DEPARTMENT OF THE ARMY
FORT WORTH DISTRICT, CORPS OF ENGINEERS
PO BOX 17300
FORT WORTH, TEXAS 76102-0300

November 28, 2014

Re: Response to Comments
Fort Hood Biotreatment Facility – Coryell County
Municipal Solid Waste (MSW) – Application No. 42040
Registration Application – First Technical Notice of Deficiency (NOD) Response to Comments
Tracking Nos. 18090338, 18105382, and 18571046; RN105463475/CN600126262

FIGURE
 III.1

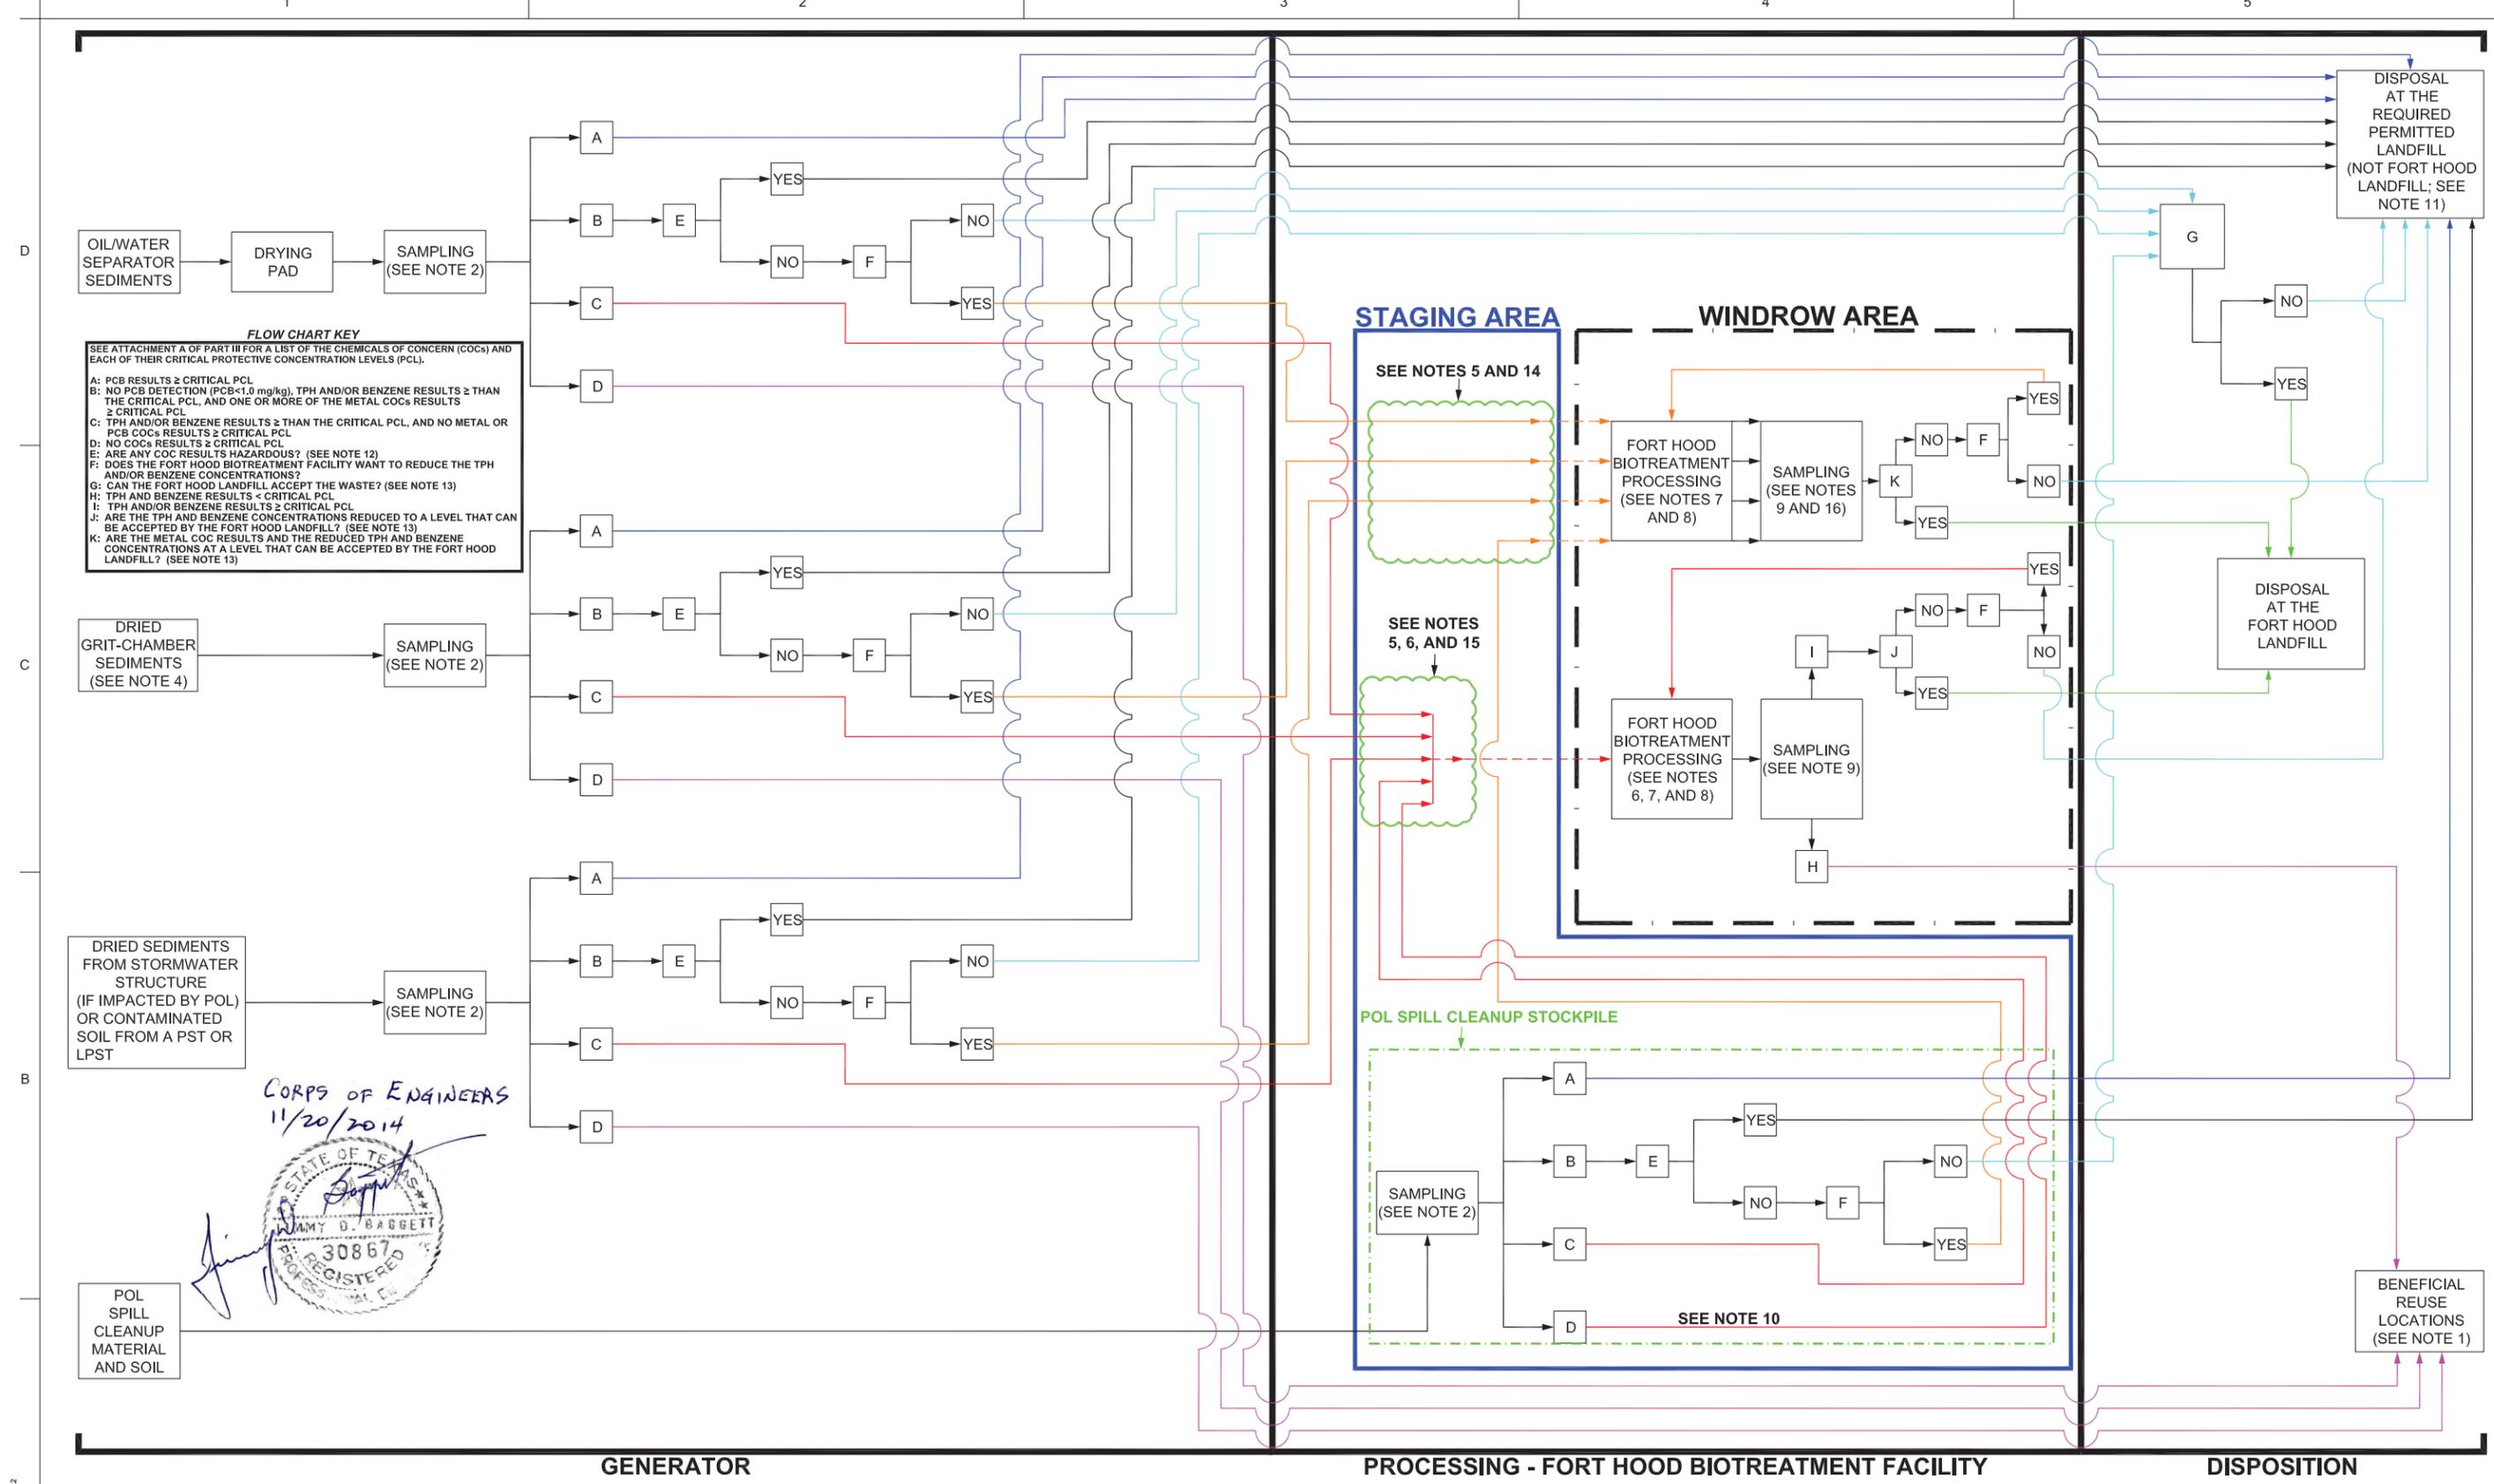
- 8. Wash water and runoff from precipitation is intended to collect on the west end (sump area) of the facility, where it will either be allowed to evaporate or be discharged to the off-site closed loop water recirculation system. Please describe the recirculation system in more detail (including location, capacity, ultimate use of the water, and any regulatory restrictions). Also, please discuss whether the closed loop recirculation system has the capacity to handle drainage from the 25 year, 24 hour storm event.**

The closed loop water recirculation system incorporates the use of a series of basins, lagoons, chambers, and a small marsh to separate sediments and chemicals from discharges associated with a vehicle wash facility that is located north of the Fort Hood Biotreatment Facility (see Figure III.1). The water is ultimately recycled within the close loop system and stored in a large pond (see "Large Basin" on Figure III.1). The water in the Large Basin serves as the water source for the vehicle wash facility whose discharges are reintroduced into the recirculation system for treatment. The water in this closed loop water recirculation system is not and does not discharge to the water of the state. There are no regulatory restrictions associated with the closed loop water recirculation system. Figure III.1 has been revised to identify the "Large Basin" within the closed loop water recirculation system.

The closed loop water recirculation system cannot handle the entire volume of potential discharge associated with the Fort Hood Biotreatment Facility during a 25-year 24-hour storm event. As such, the discharge from the Fort Hood Biotreatment Facility will be controlled utilizing an existing 6-inch valve (see Figure III.6) to ensure the holding capacity of the "Large Basin" of the closed loop water recirculation system is not exceeded. The "Large Basin" has a holding capacity of approximately 500,000 gallons while the Fort Hood Biotreatment Facility produces approximately 360,900 gallons of potential discharge from a 25-year 24-hour storm event.
